**Joseph M. Farley Nuclear Plant**  
**Inservice Inspection Relief Request Numbers R-44, RR-45, R-46 and RR-47**

**SOUTHERN NUCLEAR OPERATING COMPANY  
ADDITIONAL RESPONSES TO NRC QUESTIONS**

SOUTHERN NUCLEAR OPERATING COMPANY  
FARLEY UNIT 2  
REQUEST FOR RELIEF NO. RR-45 FOR EXAMINATIONS  
TO THE 1989 ASME CODE

SKETCH 1  
Unit 2 ISI Intervals and Code Applicability

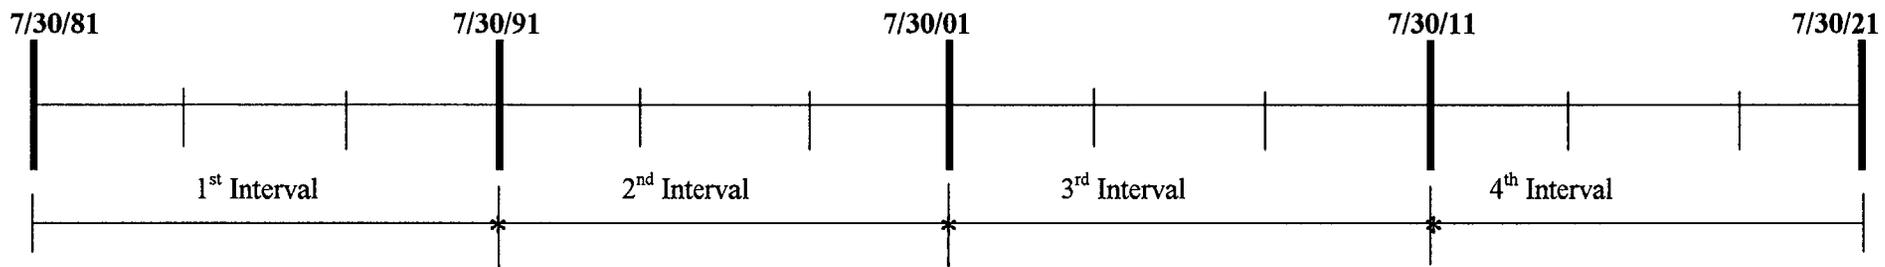
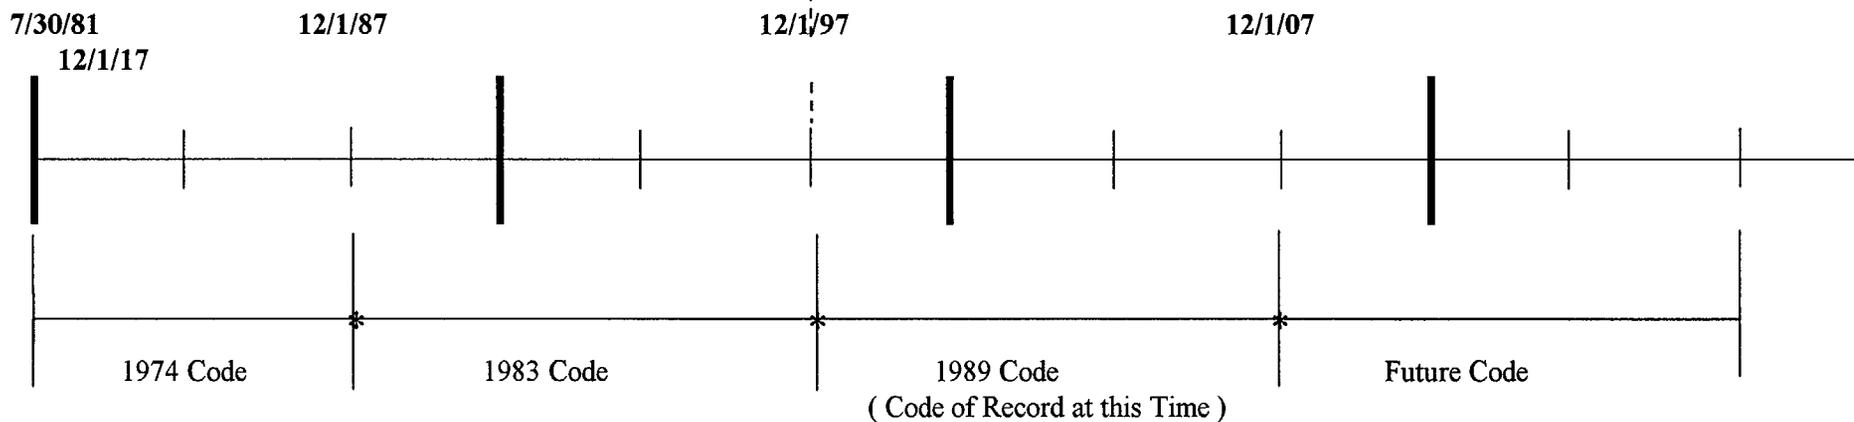
**1) NRC Question:** Please clarify what is meant by an interim interval. There is no such thing as an 'updated' or 'current interval' in the context that the licensee is using. They are either in their second or third interval. There are no in between.

**SNC Response:** The Unit 2 Second Interval consists of 1983 Section XI examinations for the first two periods and due to the early Code update to coincide with the Unit 1 update, the third period examinations were performed using the 1989 Section XI. The terminology that has been used was an effort to differentiate between the two ASME Code Editions used in the same 10-year interval.

NRC SER dated March 20, 1997 approved the early update of the Unit 2 ISI and IST Programs and Plans so that Units 1 and 2 would be on the same update schedule. (Please note that on August 31, 1988, NRC first approved this early update approach for the Unit 2 ISI and IST programs.) The scheduling and sequence of examinations and the ASME Code completion requirements per period are based on the 10CFR50 interval definition and are not affected by the early update.

In the 1997 SER referenced above, NRC acknowledged that SNC was to continue this early update practice for Unit 2 until the end of life. In this manner, Units 1 and 2 will always be updated simultaneously to the same ASME Code but the update for Unit-2 will not coincide with the 10-year anniversary of the commercial power date per 10CFR50. See Sketch 1 for clarification.
